Audi / SEAT / Škoda / Volkswagen

There are three generations of servoelectric. ZF Services sells the current generation III steering gear. The steering gear from generation I and II are no longer available.

Fig. 3: Generation III

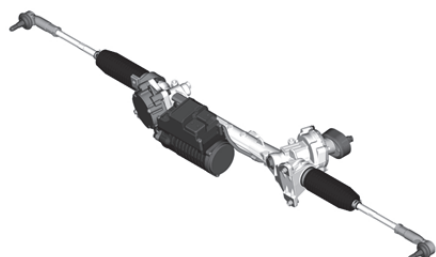
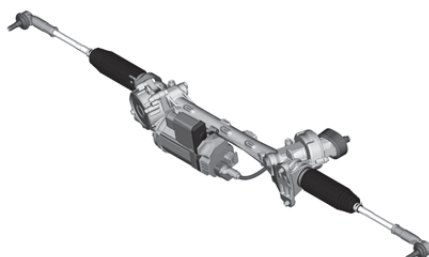
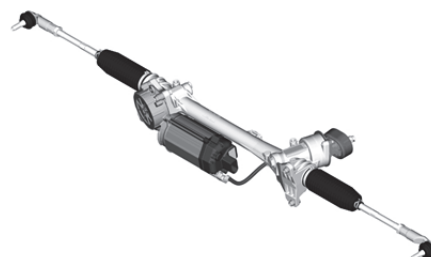
The generation III steering gears are adjusted to the modified vehicle electronics. The generation III steering gears can also be installed in vehicles that are originally equipped with generation I or II steering gears utilizing a compatible cable set.

Retrofitting Generation II → III		Number of fastening points	
		Cable set	Other parts	Body	Steering gear Gen. III
Original Equipment : Generation III	2009 →	No	No	3	3
Original Equipment : Generation II	→ 2009	Yes ³	No	4 ⁵	3
Original Equipment : Generation I	2003/2004 ²	Yes ³	Yes ⁴	4 ⁵	3

- ² It can be determined whether a generation I, II or III steering gear has been installed as original equipment via the 10-digit ZF Lenksysteme article number. This article number can be found on the metal plate attached to the steering gear.
- ³ The cable set between steering gear and vehicle electronics has to be retrofitted to the generation III version. The cable set is vehicle-specific and only available at authorized dealers. The article number can be found in the WebCat online catalog, on the InCat DVD and at TecDoc.
- ⁴ Generation I vehicles, depending on the vehicle type, have to be retrofitted with additional parts (axle bracket, panel, a.o.). The parts are vehicle-specific and only available at authorized dealer
- ⁵ The fourth fixing point is no longer used with the installation of a generation III steering gear.
